# DEVELOPMENT REVIEW COMMITTEE

## CASE COMMENT REPORT

CASE NO. UDP-S23066

Case Number: UDP-S23066 (2200 Ponderosa Plaza– 2205 NW 6 ST)

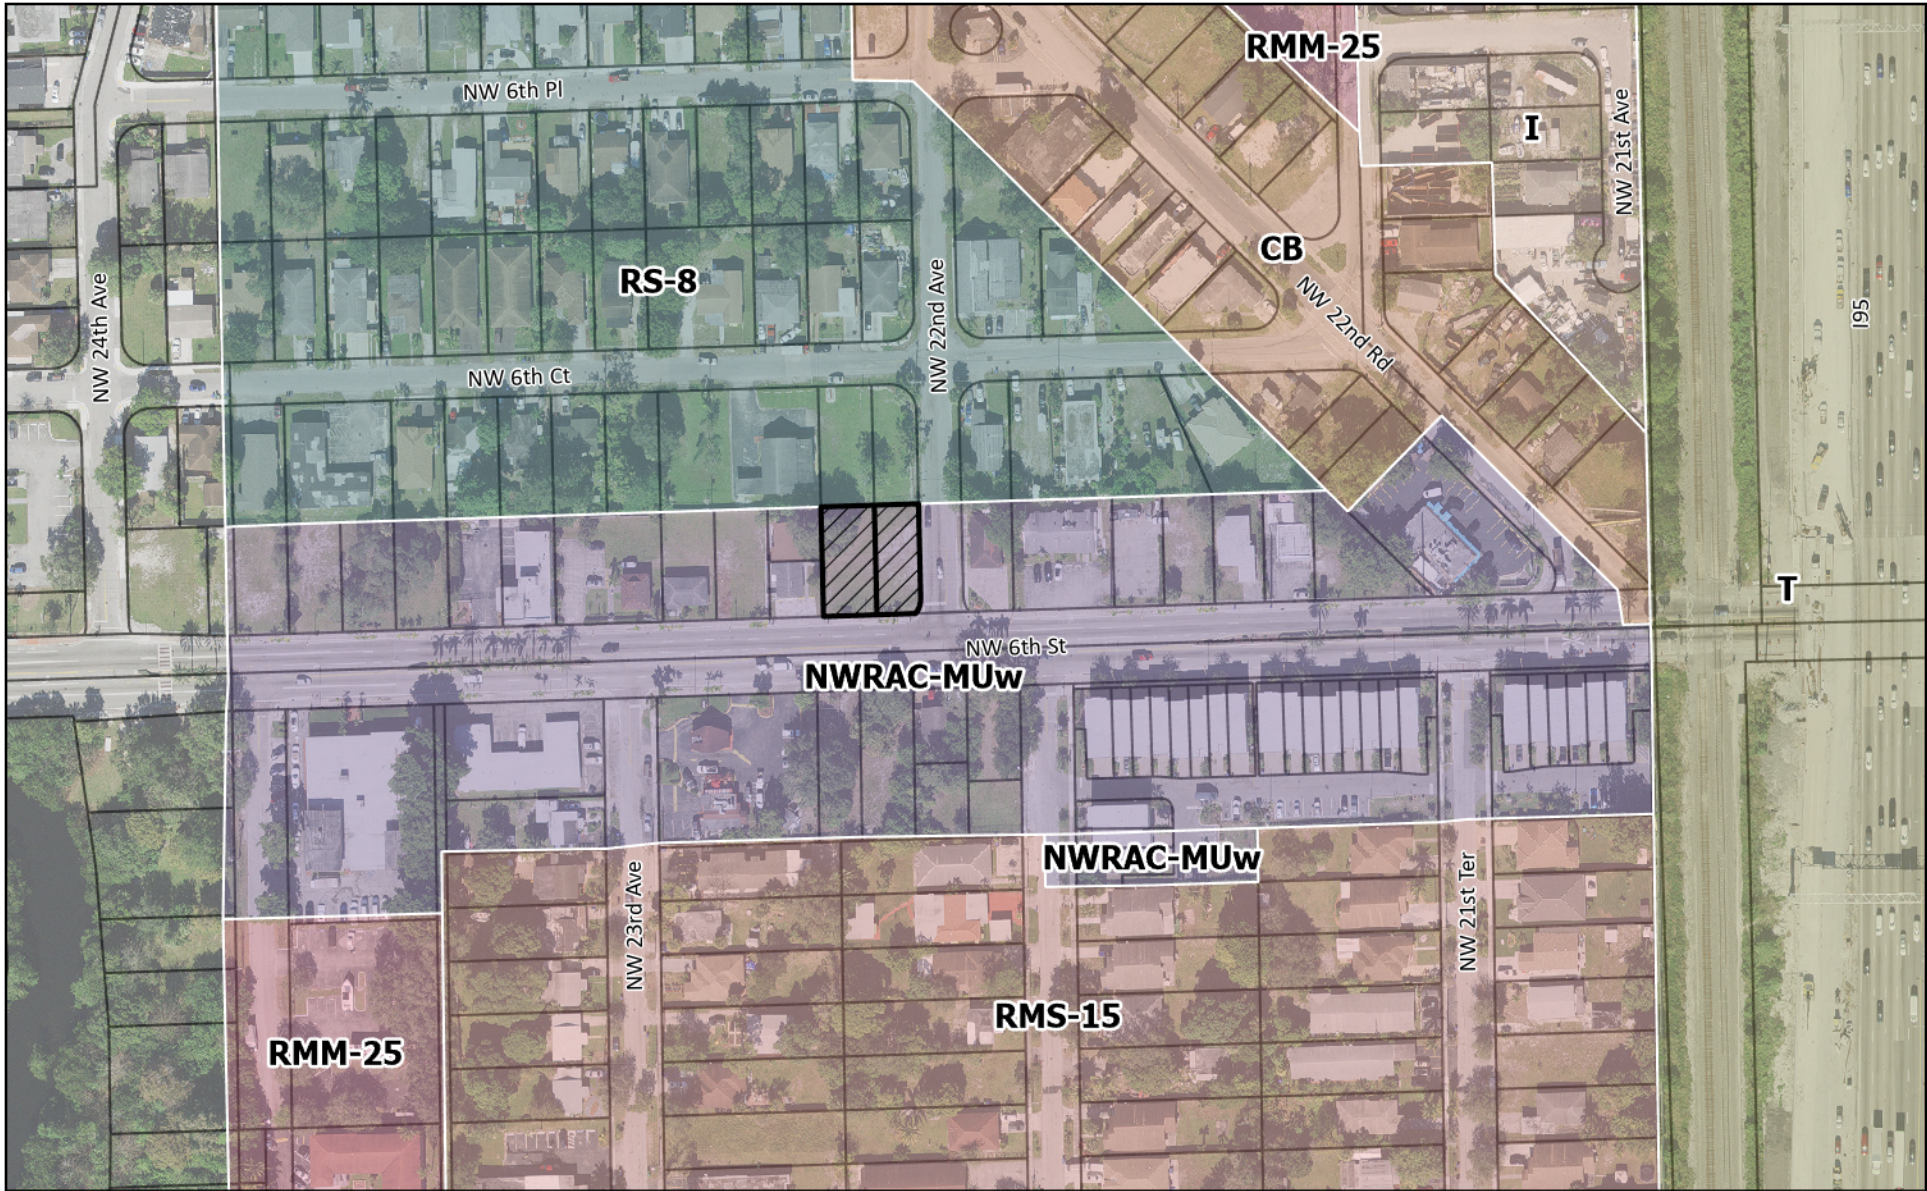
- f. B5- Reference Comment B-3 of the Building Design Standards
- g. B14- Provide additional architectural design changes. Cornices should be added to the roofline of the building to reflect a change in materials and building color.
- h. B15- Provide additional diversification in façade materials. The materials should be reflective of the local character of Sistrunk Boulevard. For example, the nearby townhomes along Sistrunk Boulevard show the utilization of a range of architectural materials (see example below).
